# IEEE *Draft* P802.3cg/D3.0 10BASE-T1L LPI synchronization

## Proposal relating to comment i-285

MICK MCCARTHY, ANALOG DEVICES

24 MAY 2019

# Figure 146-14 – PHY Control state diagram (part a)

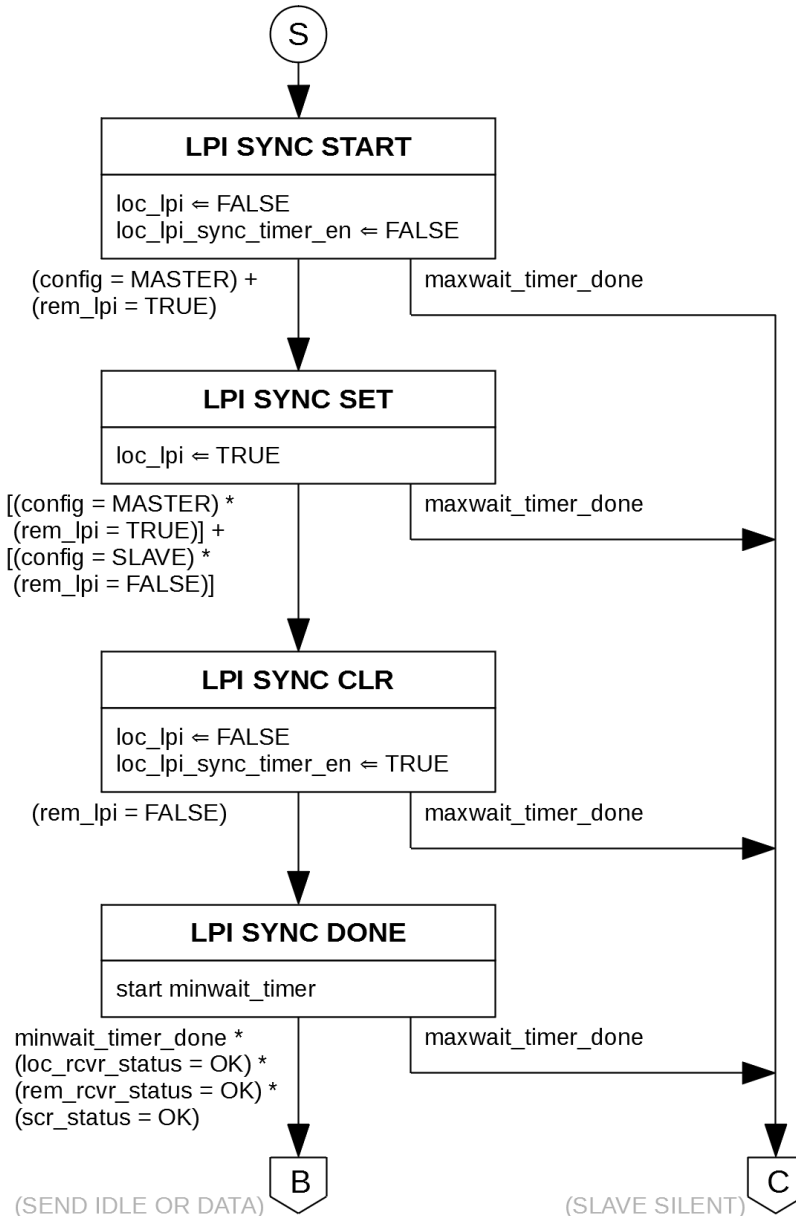
- ▶ Added entry to LPI synchronization sequence on exit from SEND IDLE state for LPI mode (labelled 'S' in diagram)
- ▶ New output from PHY Control state diagram: `loc_lpi_timer_sync_en`
  - TRUE enables local LPI synchronization timing
  - FALSE disables local LPI synchronization timing
  - Not encoded in transmit symbol stream; no new communicated parameters required
- ▶ Note some minor corrections
  - Use of `!maxwait_timer_done` in exit transitions from SEND IDLE
  - Renaming `loc_lpi_req` as `loc_lpi` (see later explanation)

- ▶ LPI synchronization sequence is described as follows:
  - MASTER first sets `loc_lpi = TRUE`
  - SLAVE waits to see `rem_lpi = TRUE` (from MASTER), and then sets `loc_lpi = TRUE`
  - MASTER waits to see `rem_lpi = TRUE` (from SLAVE), and then sets `loc_lpi = FALSE`
  - MASTER also sets `loc_lpi_sync_timer_en = TRUE` at the same time
  - SLAVE waits to see `rem_lpi = FALSE` (from MASTER), and then sets `loc_lpi = FALSE`
  - SLAVE also sets `loc_lpi_sync_timer_en = TRUE` at the same time

- ▶ In both MASTER and SLAVE, transition of `loc_lpi` from TRUE to FALSE occurs at the same time as start of local LPI synchronization timing (`loc_lpi_sync_timer_en` transition from FALSE to TRUE).

- ▶ LPI synchronization mechanism takes place before link startup completion (PHY Control transition to SEND IDLE OR DATA).

# LPI QUIET REFRESH timing state diagram

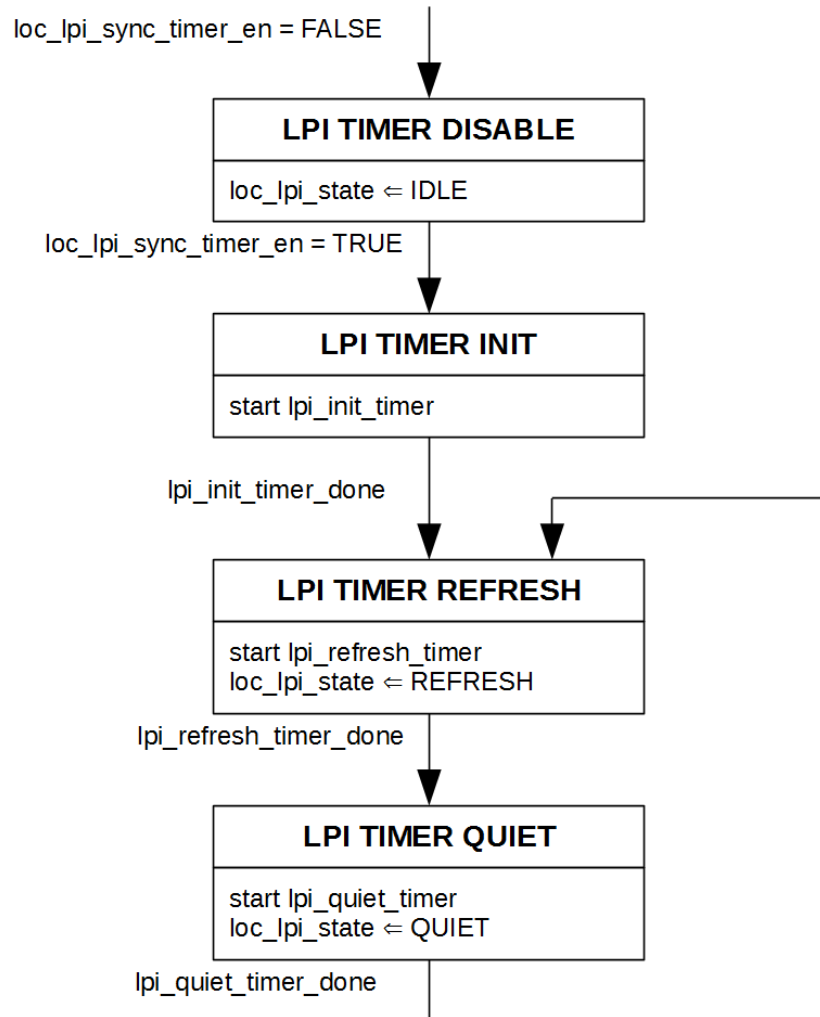
- ▶ Timing offset between MASTER and SLAVE REFRESH is effected in LPI TIMER INIT state:
  - Define `lpi_init_timer` duration differently between MASTER and SLAVE
  - MASTER `lpi_init_timer` duration 0  $\mu$ s
  - SLAVE `lpi_init_timer` duration 3000  $\mu$ s
  - This offset, i.e. 3000  $\mu$ s, should be maintained for lifetime of link
- ▶ Maintain `lpi_refresh_timer` and `lpi_quiet_timer`:
  - `lpi_refresh_timer` 250  $\mu$ s
  - `lpi_quiet_timer` 6000  $\mu$ s
- ▶ All timers here would be synchronized to symbol period (TX\_TCLK). Might be defined in terms of symbol periods.
  - As SLAVE maintains timing lock with MASTER, so timing relationship between MASTER and SLAVE LPI QUIET REFRESH cycling should also remain fixed (and predictable)

Figure 146–15—PHY Control state diagram (part b)

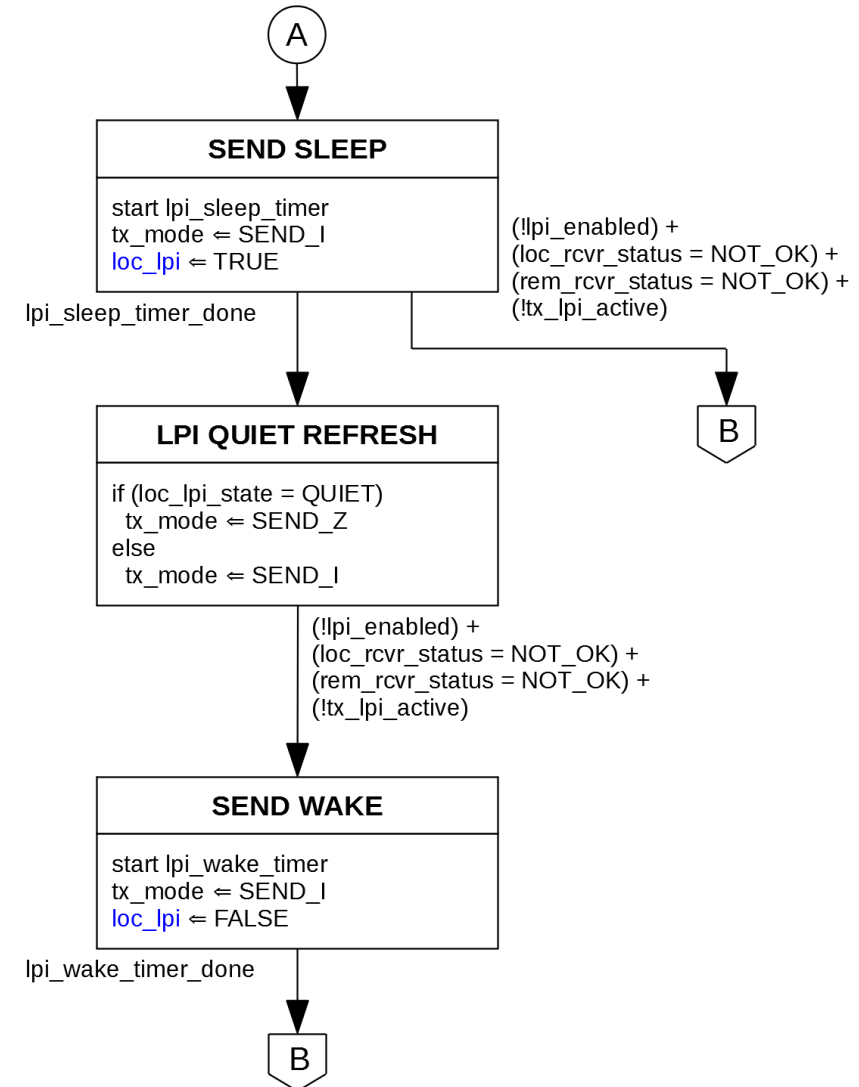
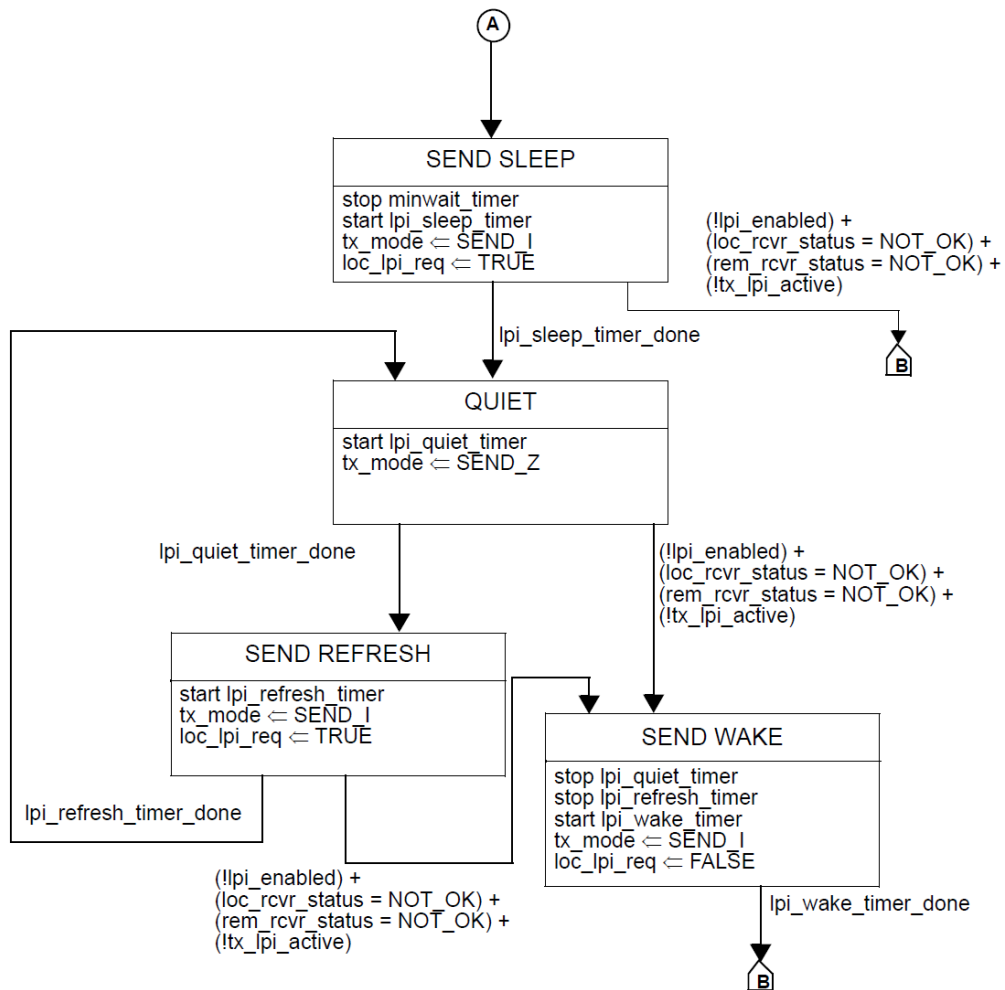
- ▶ PHY Control LPI sequencing is simplified
  - Combined LPI QUIET REFRESH state, with QUIET/REFRESH mode determined by `loc_lpi_state` variable

# PHY Control LPI sequencing – lpi\_sleep\_timer duration

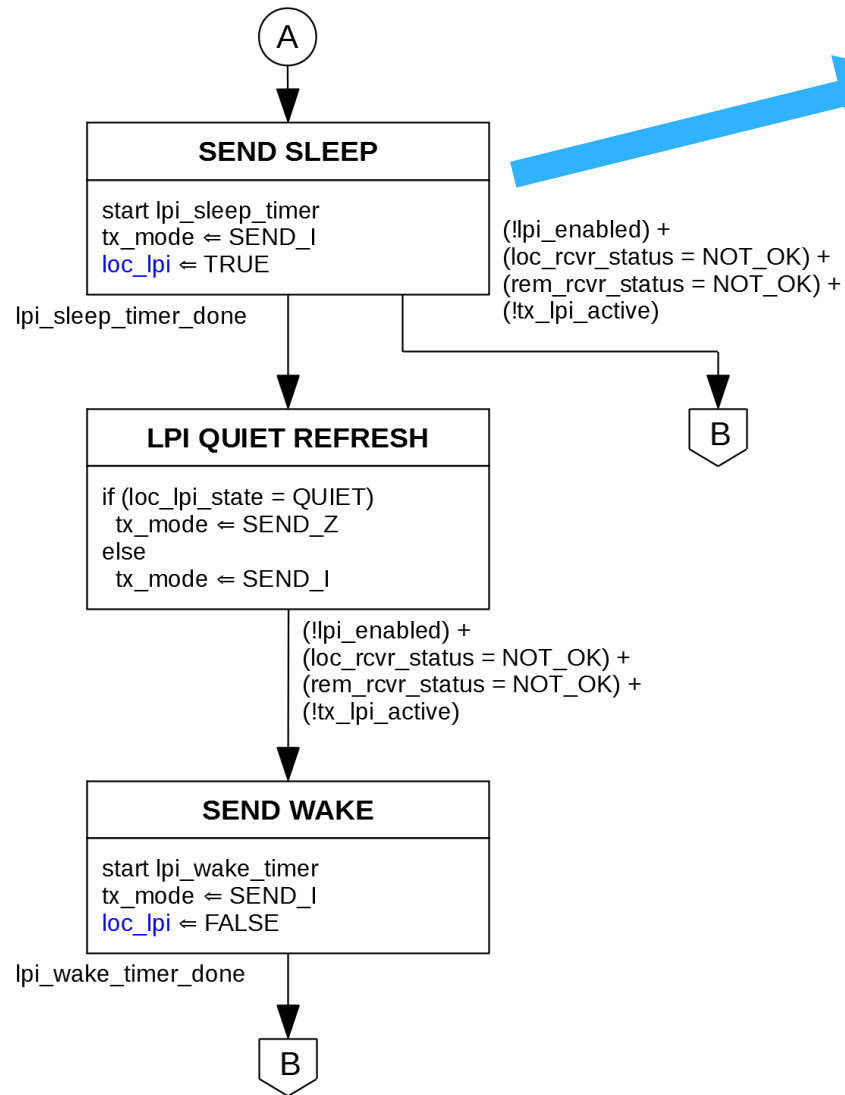
- ▶ Propose to reduce lpi\_sleep\_timer duration
  - Currently this is set to 250  $\mu$ s (as per [Graber 3cg\\_01a\\_0419](#))
  - The reason for the relatively long duration here is to allow any ongoing adaptation tasks to complete before transmission ceases in QUIET state.
  - But, given that link partner LPI QUIET REFRESH cycling can be known with certainty, a PHY should align to this, and should never require a longer duration in SEND SLEEP.
  - Propose lpi\_sleep\_timer duration of 20  $\mu$ s, same as minwait\_timer duration.
  - Might be specified in terms of transmit symbol periods.

**Figure 146-11—PMA functional block diagram**

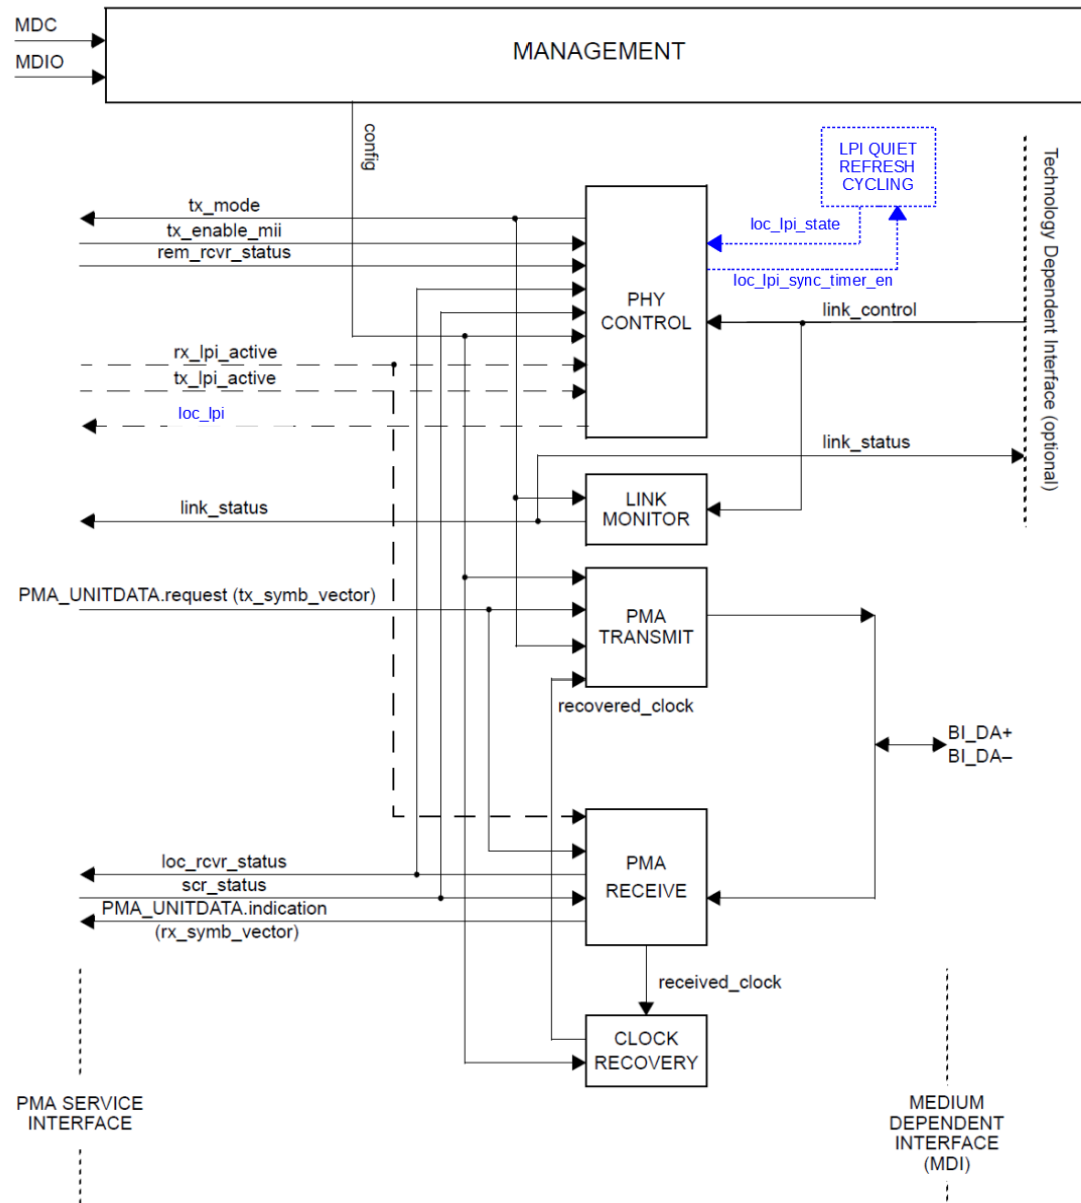
NOTE 2—Signals shown with dashed lines are required only for EEE functionality.
